Subject: Docket Number 070-03098
Duke Cogema Stone & Webster
Mixed Oxide Fuel Fabrication Facility
Response to Request for Additional Information

Non-Proprietary Response to Request for Additional Information

Figure RAI-012-5. EPRI mean and fractile uniform hazard spectra for SRS hard-rock site conditions for an approximate annual probability of exceedance of 10^{-4} .

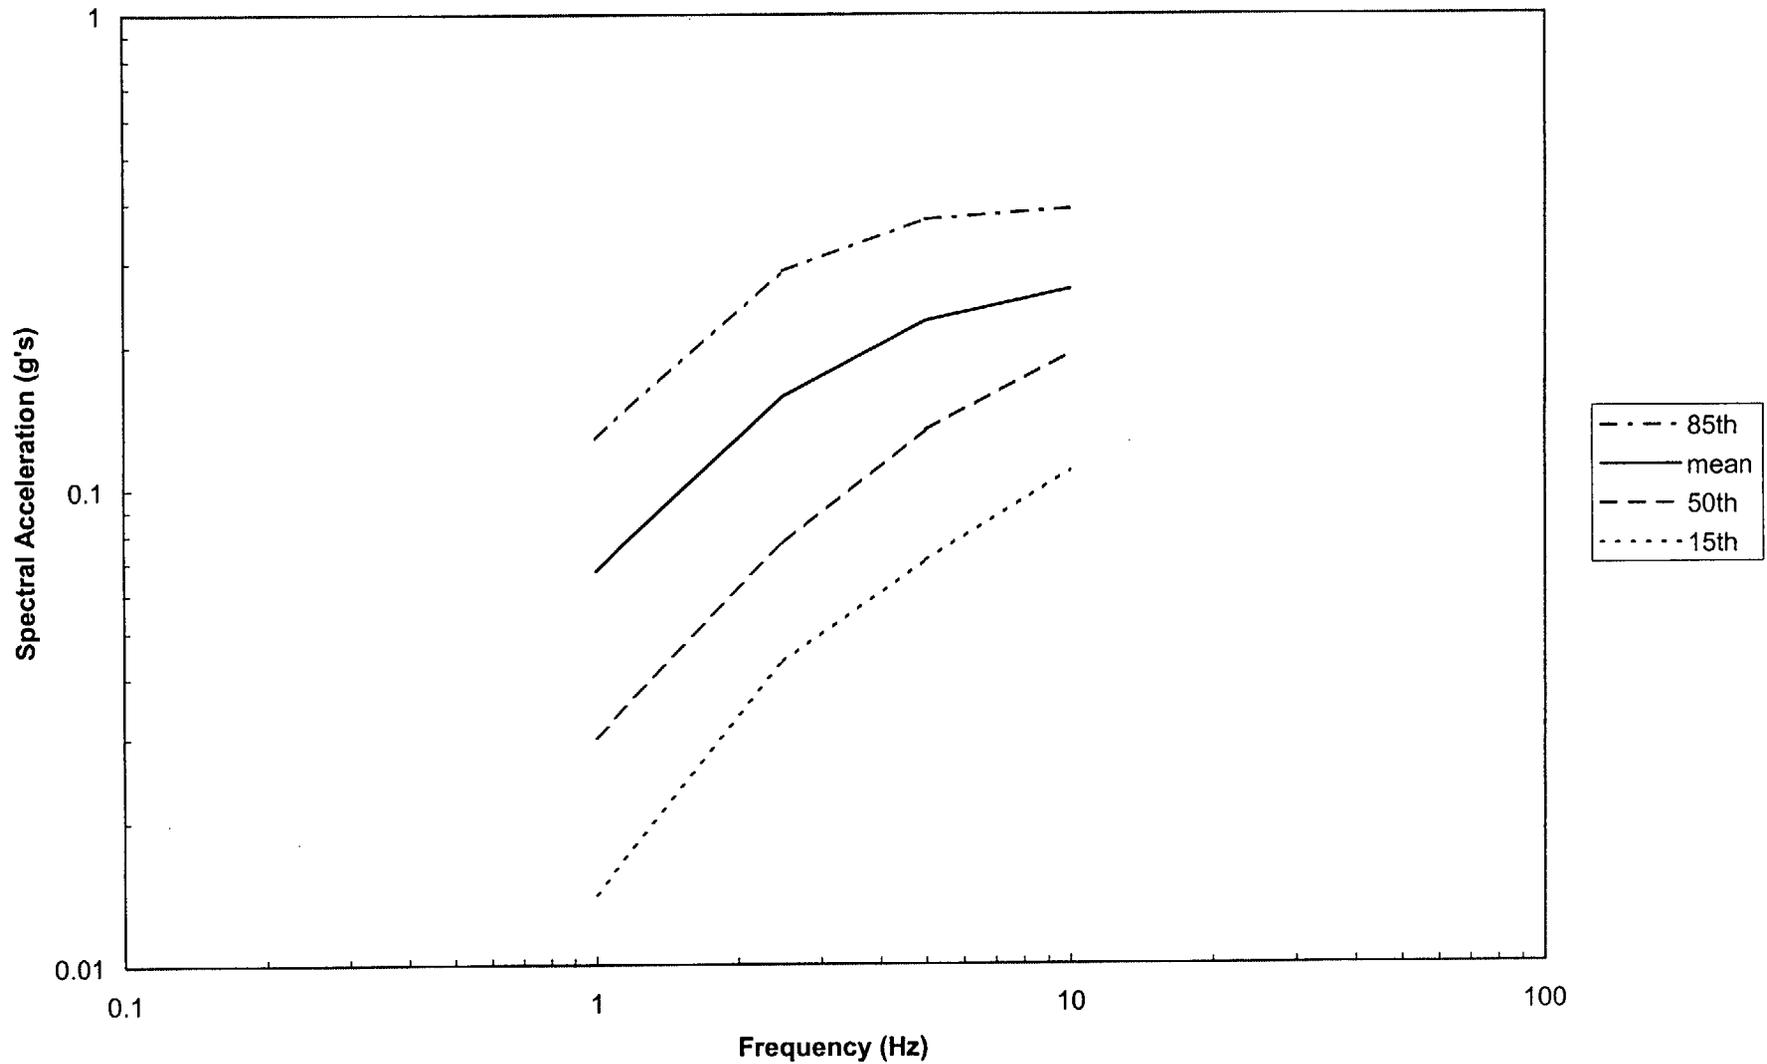
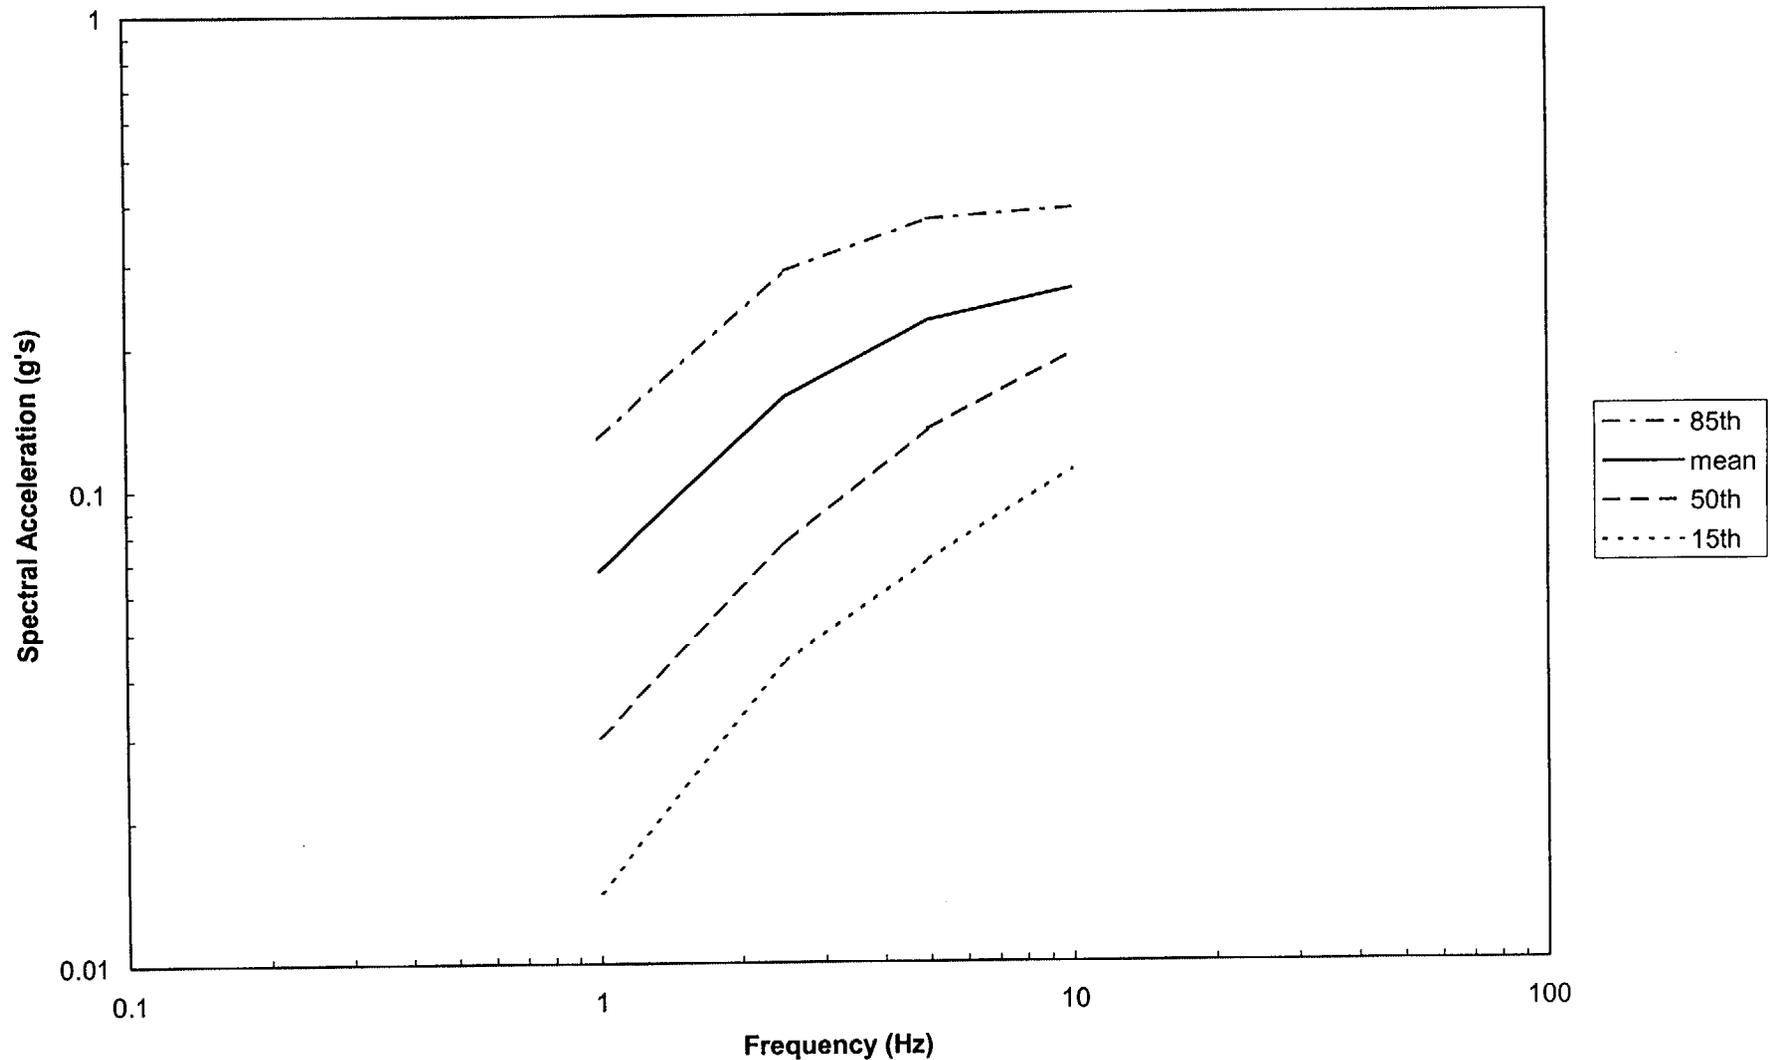
Provide the following items for the Probabilistic Seismic Hazard Assessment (PSHA):

EPRI mean and fractile hard-rock uniform hazard spectra (UHS) for the SRS are illustrated in the attached Figure 5 for an approximate annual probability of exceedance of 10^{-4} .

Figure RAI-20-1 SRS Soil Surface Seismic Hazard Curves

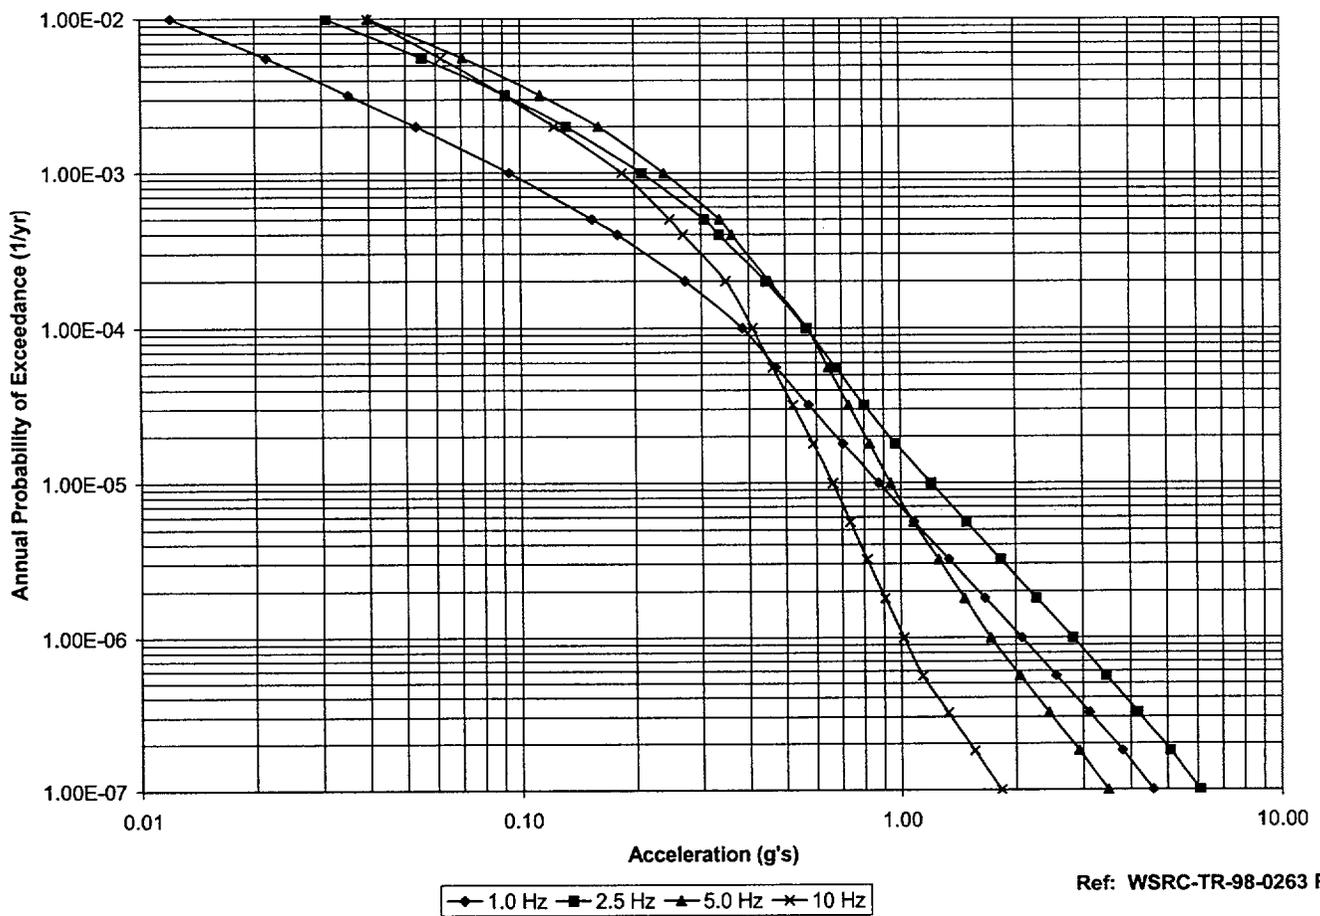
It appears from the application that the return periods were chosen from 5 Hz spectrum accelerations (Table 1.3.6-7 and Figure 1.3.6-16). The applicant did not give the bases and purposes for evaluation of return periods from 5 Hz spectrum accelerations.

Section 1.3.6.6 on page 1.3.6-23 describes the selection of the MFFF Design Earthquake, using the SRS site-wide criteria as an input. The narrative refers to Figure 1.3.6-16 as representing the soil surface hazard relationships for SRS. Figure 1.3.6-16 expresses the hazard in terms of spectral velocity versus annual probability of exceedance. The source document that developed this hazard definition (WSRC, 1998, shown in the CAR as "Lee, R.C., 1998,") also contains representations of the hazard in terms of spectral acceleration. The attached Figure RAI-20-1 shows the appropriate soil surface acceleration hazard curve.

Using the acceleration hazard relationships shown in Figure RAI-20-1 for each of the four oscillator frequencies (1 Hz, 2.5 Hz, 5 Hz, and 10 Hz) represented in the hazard chart, the spectral acceleration was read off each of the 5% damped response spectra discussed (CAR - Figure 1.3.6-20 for PC-3, Figure 1.3.6-14 for PC-4, and Figure 1.3.6-21 for Regulatory Guide 1.60). These spectral accelerations were used to enter Figure RAI-20-1 and to read the associated annual mean probability of exceedance. Inverting the annual mean probability of exceedance results in the return period reported in CAR Table 1.3.6-7.

To provide additional clarity, Figure RAI-20-1 will be included in the next update of the CAR, and will be cited in CAR Section 1.3.6.6.

DCS Operations Phase

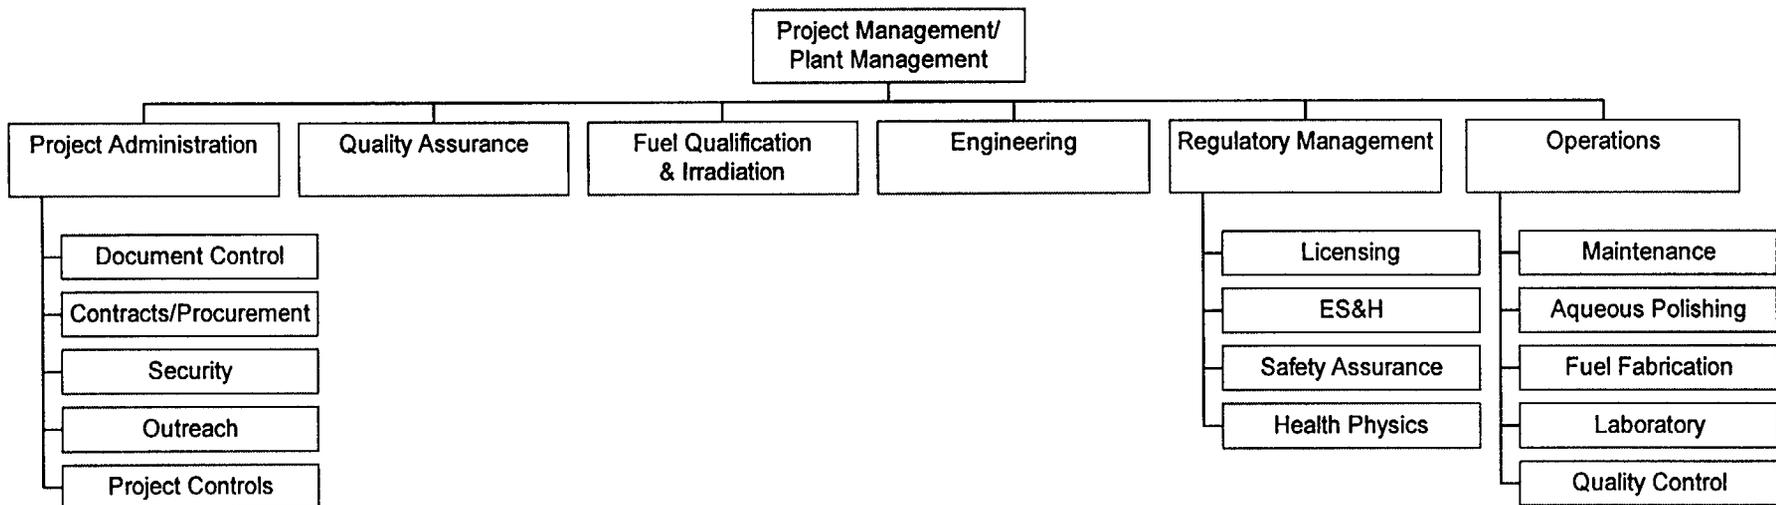
Figures 4-1 and 4-2 provide organizational charts. The NRC would anticipate that Figure 4-1 would be more explicit vis-a-vis positions, the location of the Safety Assessment manager and safety activities, and current design and regulatory activities. Current names and qualifications of individuals should be supplied. In addition, on Figure 4-2, the NRC would anticipate, there should be a link between regulatory manager and corporate management, including corporate safety management.

Figure 4-2 has been updated to show the functional relationships of the organization for the operations phase of the project. This organizational chart (see attached sketch) details the proposed DCS organization for the operations phase of the project. The organization for the initial operation phase will include the engineering, construction, and start-up elements until final turnover to operations is complete.

In the next update of the CAR, replace Figures 4-1 and 4-2 with the new project, construction, and operations charts; add position descriptions for the additional positions indicated above; and clarify reporting relationships as discussed above.
